SPECIAL USE EXCEPTION PETITION REVIEW REPORT

Petition Number: Z 20-06

Project Name: BeerSauce Shop

Requested Action: Special Use Exception for
Restaurant Use
Alcohol Provision
Front Yard Parking

3 Architectural Site Plan
30'-0" = 1"

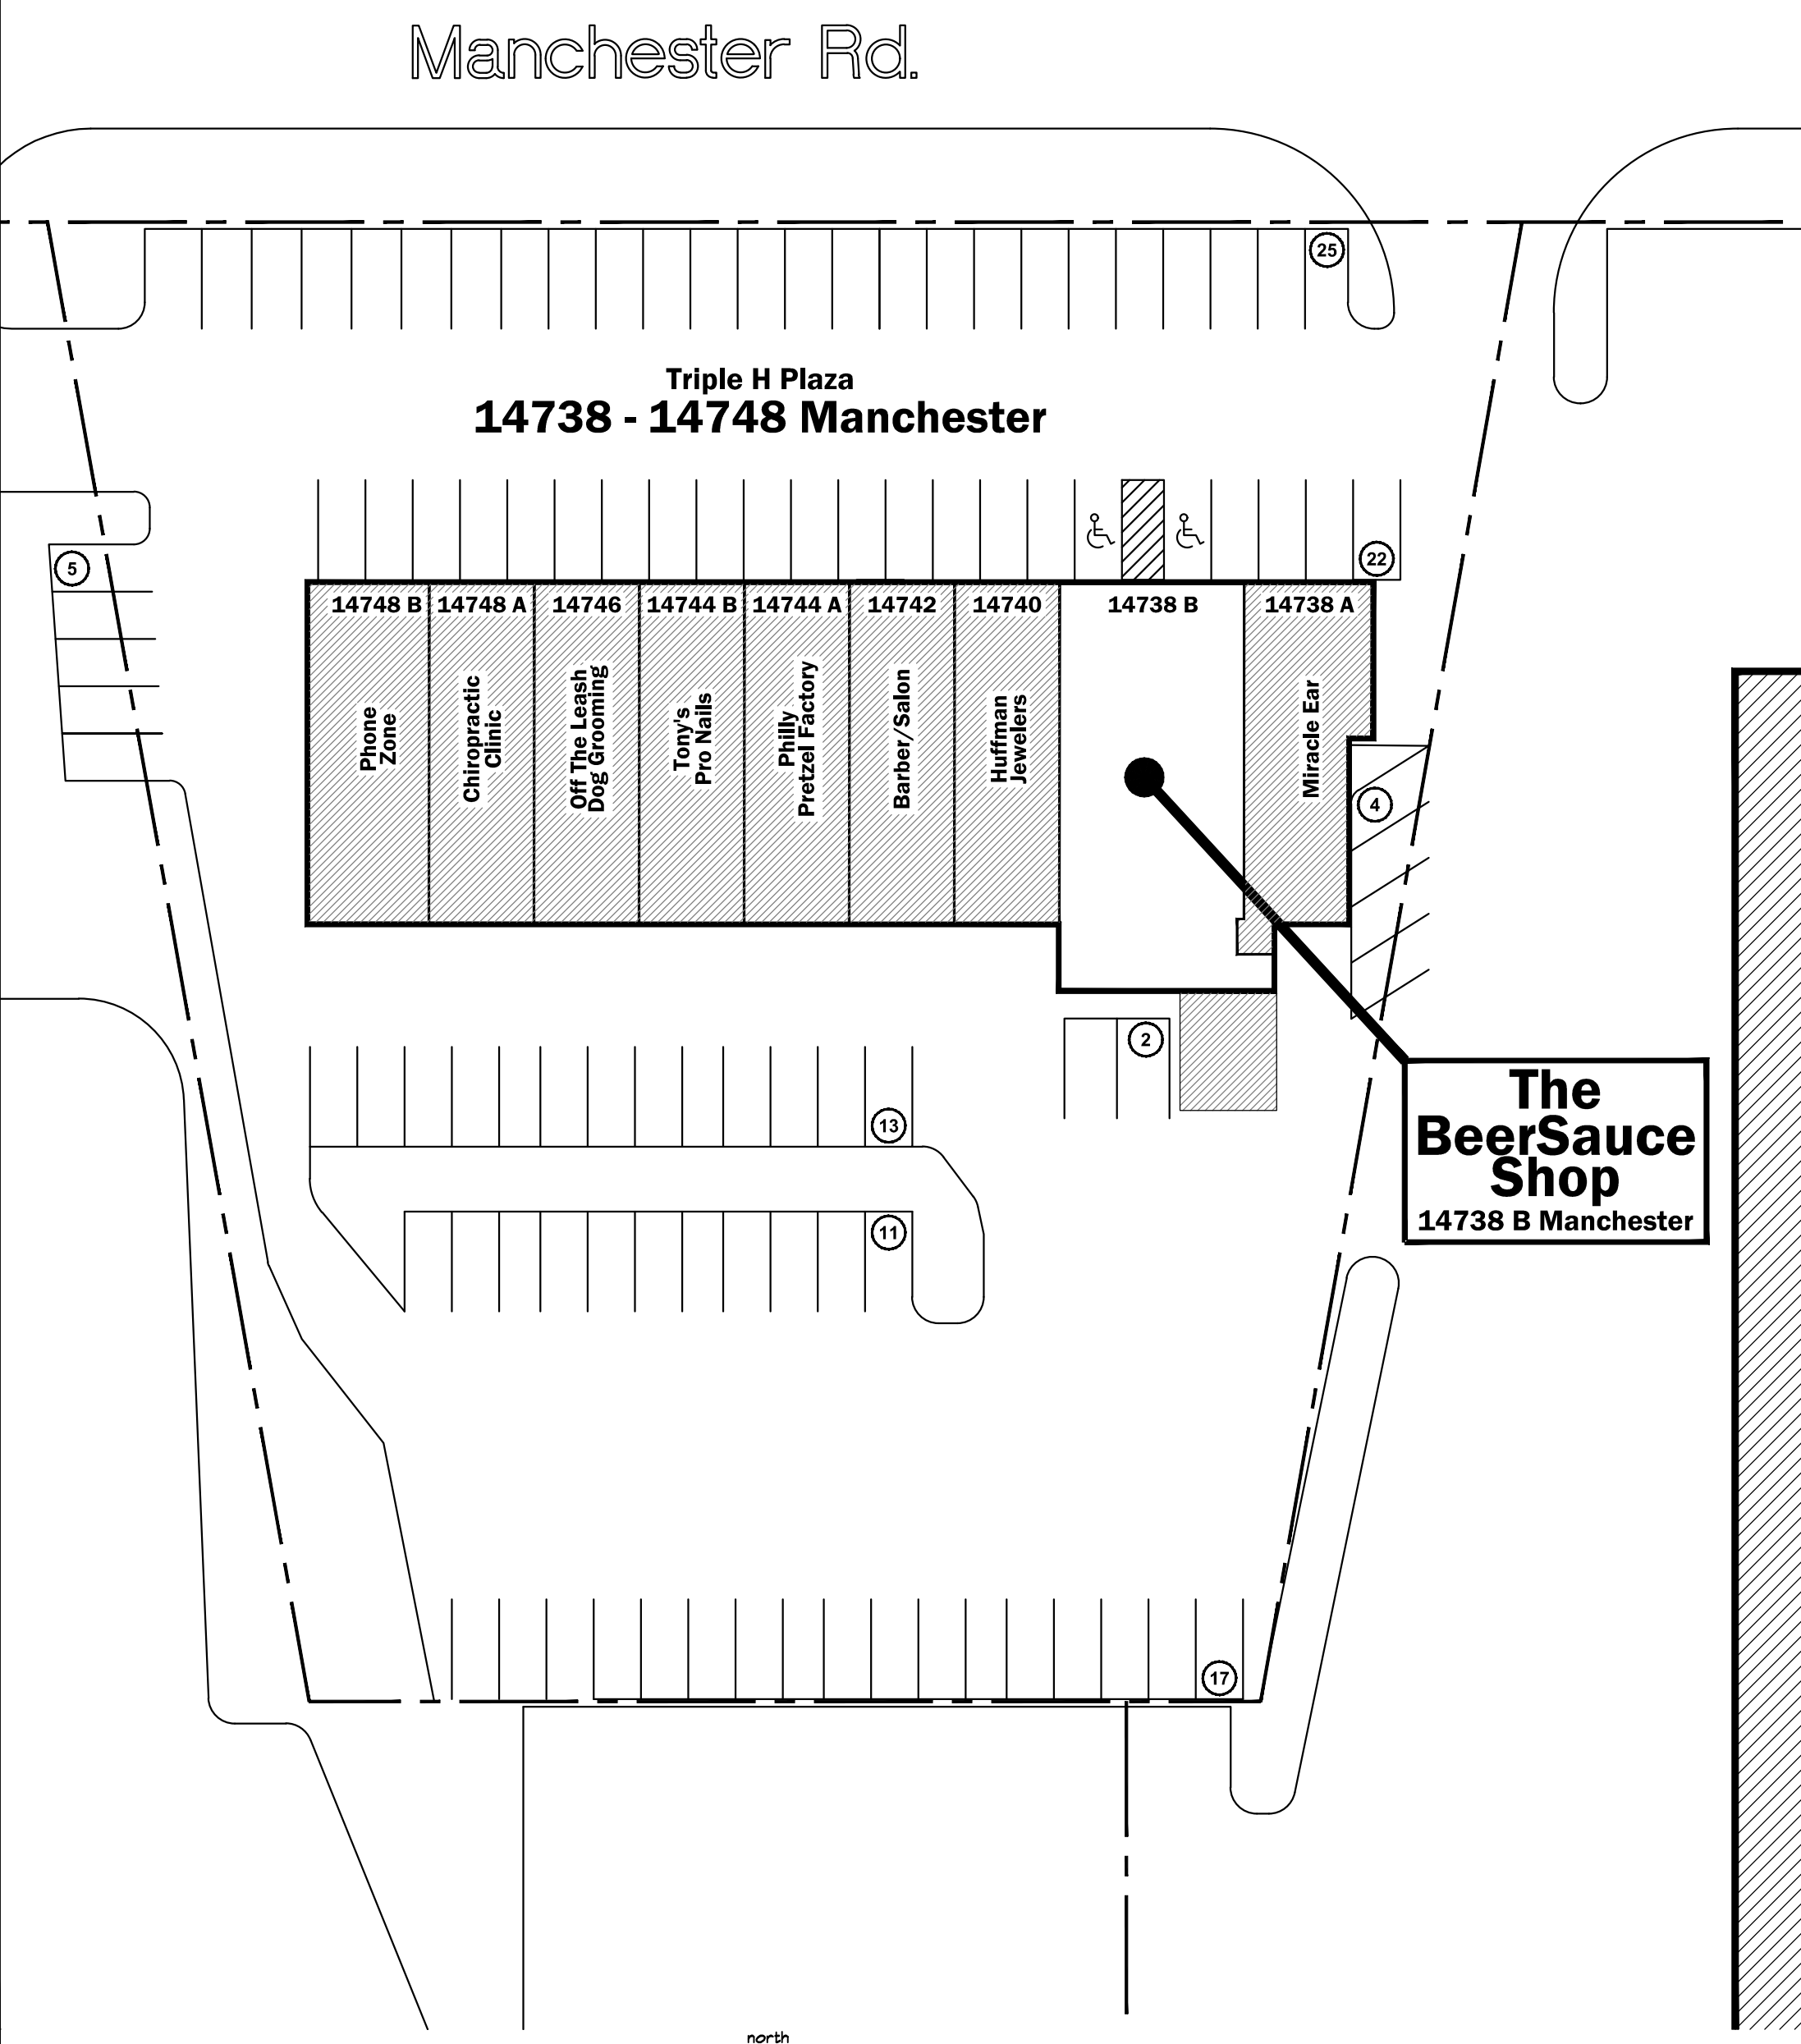
- Art. IX, Sec. 3 establishes a height limitation of 45.’ The proposal at hand is not proposing any change to the currently approved architecture.
- Art. IX, Sec. 4 (1) establishes a front yard depth of not less than 40.’ except for: Art. XI, Sec. 4 (1) (iii) Land lying along Manchester Rd, along which a front yard is required to have a depth of 20’ with no parking to be allowed.

By this calculation, approximately 13 spaces in this parking lot are allocated to this particular suite. The parking area for Triple H Farms Plaza provides approximately 100 spaces. The plaza currently has a few vacancies, but if you consider their previous tenants, the location generally attracts restaurants and a variety of services for medical purposes, pet care, or electronics repair. Restaurant and Retail: 1 parking space per 200 sq ft/ Medical Service: 1 parking space per 250 sq ft.

Total required parking spaces for these aggregate locations would be approximately 69 spaces; including BeerSauce, 82 spaces would be required. The plaza has adequate parking.

- Art. IX, Sec. 7 (3) requires that commercial parking lots be interconnected or that a cross access, driveway/parking lot vehicular interconnection easement" be established to the benefit of Ballwin to allow a future parking lot interconnection with adjoining properties, No change to the previously approved site plan is proposed by the petitioner.

- Art. XIV, Sec. 2 (12) refers to rubbish and trash disposal and screening. The use proposed does not appear to be one that would generate substantial trash. There is an existing dumpster location in the rear of the building.
